Product Change Notification

PCN-CST-3314-2019

Business Unit	Product Line Code	Type of Change	Action	Date of Issue
CST - Control Systems	DRA	Product Change Notification	Notify Distributors and Field	3/4/2019

Description for Product Change Notification

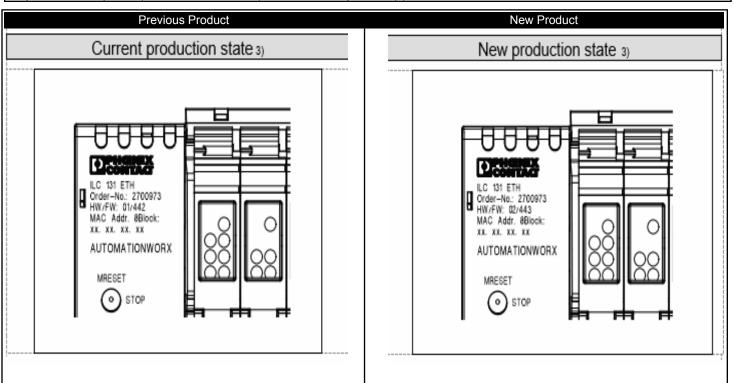
The controller class 1xx undergoes a hardware technical revision. The device receives a new Flash memory. A new hardware revision and a firmware version (the functionality is identical to 4.42) will be created in the context of the review. The compatibility regarding to the hardware is ensured. The 6 month waiting period are not observed, because the abrupt Micron Flash announcement compromises the ability to deliver.
